Docket Number:	19-SPPE-03
Project Title:	Sequoia Data Center
TN #:	237579
Document Title:	Intervenor Sarvey's Reply Testimony April 28, 2021
Description:	Exhibit 312 Intervenor Sarvey's Reply Testimony April 28, 2021.
Filer:	Robert Sarvey
Organization:	Robert Sarvey
Submitter Role:	Intervenor
Submission Date:	4/28/2021 2:50:06 PM
Docketed Date:	4/28/2021

In the matter of:
Sequoia Data Center

Intervenor Sarvey's Reply Testimony April 28, 2021

Santa Clara Data Center Locations

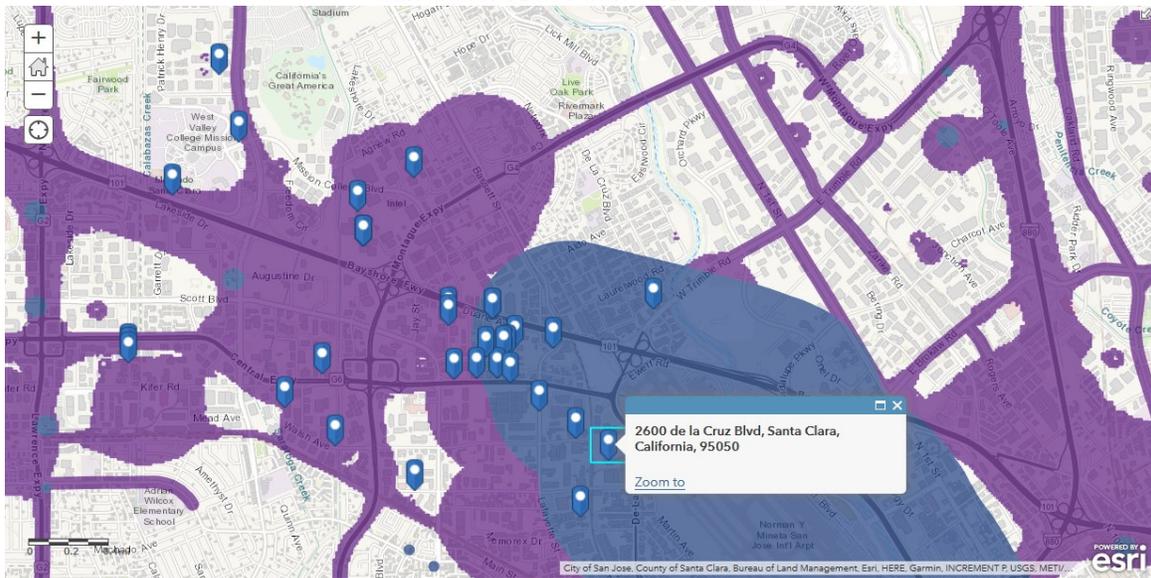
in the ambient air quality analysis for the proposed project to determine the cumulative impacts. Including these other data centers in the analysis is important given that it is unlikely the impacts from these other projects are properly accounted for in the background ambient data.²³ CEC Staff ignoring CARB's direction failed to model cumulative data center operations for violations of ambient air quality standards. There are 25 existing data centers in census tract 6085505202 listed and located in Exhibit 313 with access to 386 MW of power. The energy commission has already approved the McLaren Data Center with 47 diesel-fired backup generators, each with a peak output capacity of 2.75 megawatt (MW) in Census Tract 6085505202.²⁴ The Walsh Data Center (WDC) already approved by the Commission would consist of thirty-two (32) 3-MW diesel fired generators.²⁵ The CEC Staff is reviewing the Lafayette Backup Generation Facility (LBGF), which would have a generation capacity of up to 99.8 MW with 44 diesel-fired backup generators.²⁶ And of course, the Sequoia Data Center is being considered with 54 diesel-fired generators 96 MW of IT.²⁷ This already overburdened census tract is now facing an additional 177 diesel backup generators totaling 478.75 MW more than doubling the existing 386 MW of power already sited in Census tract 6085505202. Two other CEC data centers Laurelwood²⁸ and Mission College Data Center²⁹ are located on the border of Census tract 6085505202. Locations of the existing Santa Clara Data Centers are depicted below.

Census Tract 6085505202 where the Sequoia Project is located is in the upper 95th percentile for diesel particulate pollution for census tracts in the State of California. This census tract is already overburdened with hazardous material sites and hazardous material transportation. On March 23, 2020 over a year ago my reply testimony provided the CEC staff with the locations of several newly approved data centers.³⁰

Data Centers recently approved by the City of Santa Clara

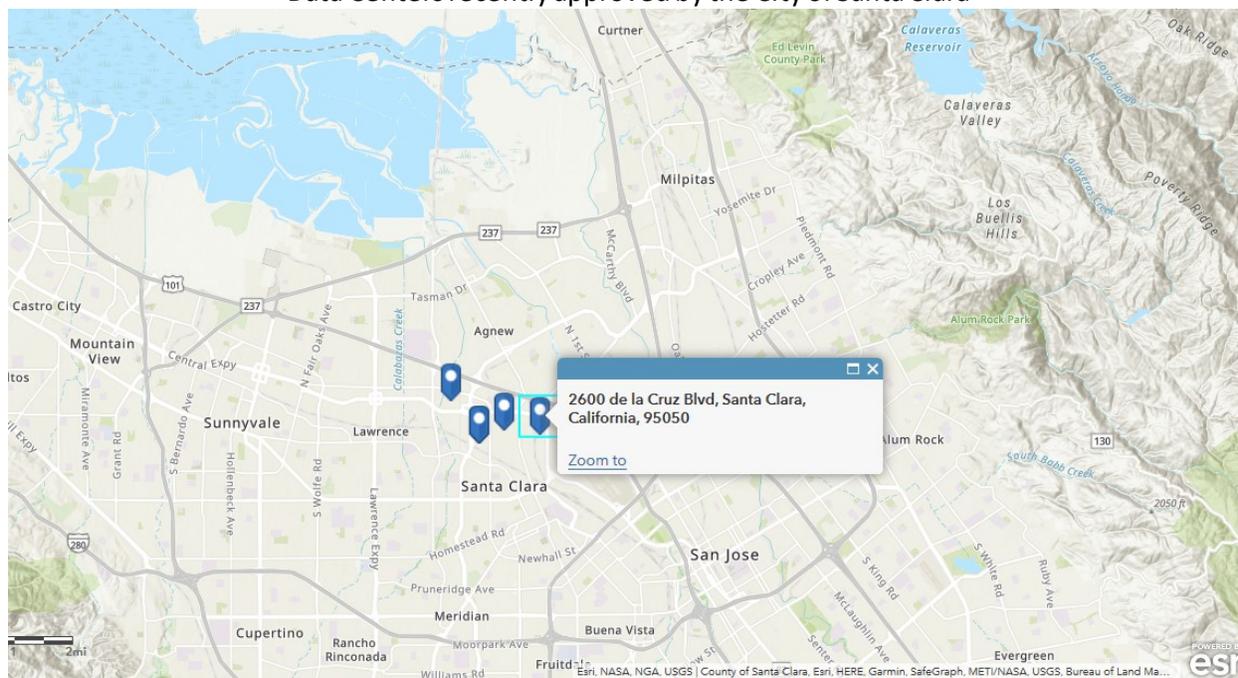
In August of 2019 the City of Santa Clara approved the 2175 Martin Avenue Data Center Project.³⁷ The project has six 2.75 MW emergency diesel generators. The emergency generators would have a total generation capacity of up to 13.75 MW.³⁸ The projects diesel generators are expected to generate 8 tons of NOx annually.³⁹ Based on the building energy and water consumption rates provided by the project applicant, the project would consume 105,003 megawatt-hours per year at buildout.⁴⁰ The projects GHG emissions from the emergency generators is 635 MT per year of CO2e⁴¹ The projects annual indirect GHG emissions from electricity use is 12,178 MT per year of CO2e annually.⁴²

In May of 2018 the City of Santa Clara approved the Coresite 8 Data Center located at 3045 Stender Way.⁴³ The project will employ ten 3 MW generators for a generating capacity of 30 MW.⁴⁴ The project is estimated to emit 32,569 metric tons of CO2e per year. The emergency generators are estimated to emit 823 metric tons per year from generator testing.⁴⁵ Testing of the projects generators is estimated to produce 12.9 tons per year of NOx and .3 tons of diesel particulate matter.⁴⁶ The data centers are located on the map below.”

Without any modeling of cumulative air quality impacts, it cannot be demonstrated that the project does not violate any ambient air quality standards in conjunction with existing and proposed sources near the project. The burden of proof that the project will not cause a significant impact has not been met.
